Service Bulletin :  
XRT Manual Platform Lower

Reference: SBU10.06

### Affected Machines: XRT Series

**Serial numbers: 10000 to 10150**

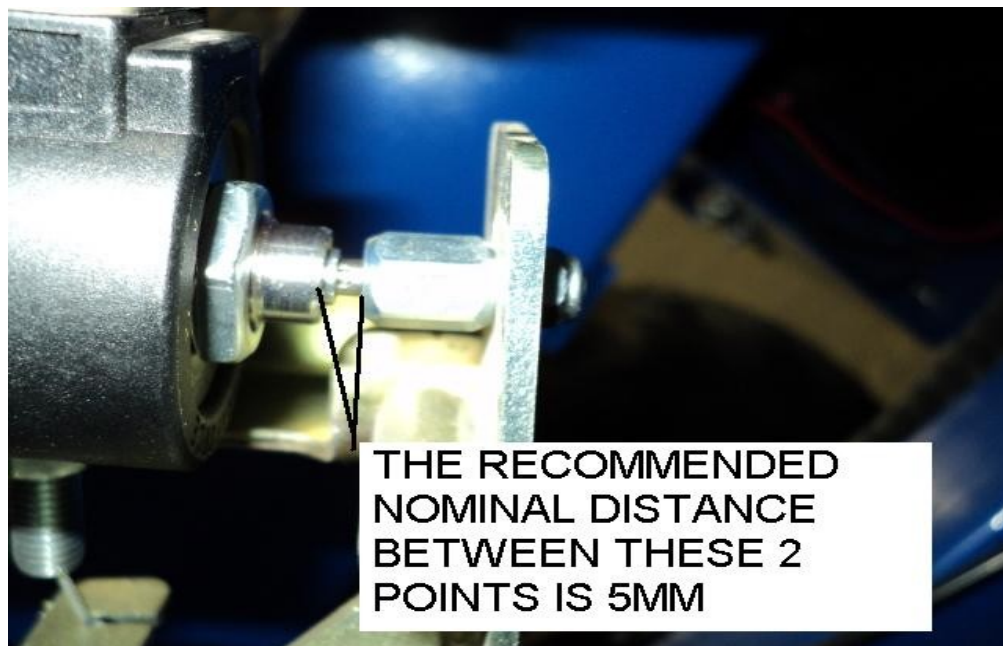
**Purpose:** The manual platform descent handle for the XRT range of machines, operates a mechanism which is attached to the bleed down valve of the lift cylinder. The lever mechanism attached to the end of the bleed down valve is secured by a 'Binx' nut (see picture below). It has been identified on a machine in service that the Binx nut had become loose resulting in non or unreliable operation of the manual lowering function.

**Procedure:** The bleed down mechanism should be examined to determine whether a Binx type nut is present. If so then this nut should be replaced using the number 10 UNF Nyloc nut along with the application of the threadlocker solution. It should be noted there must be a set gap between the body of the bleed down valve and the barrel nut behind the actuator lever (see picture below).

A modification has been introduced for new build machines, where the Binx nut has been replaced using a number 10 UNF 'Nyloc' nut with the addition of 'Loctite 243' threadlocker fluid.
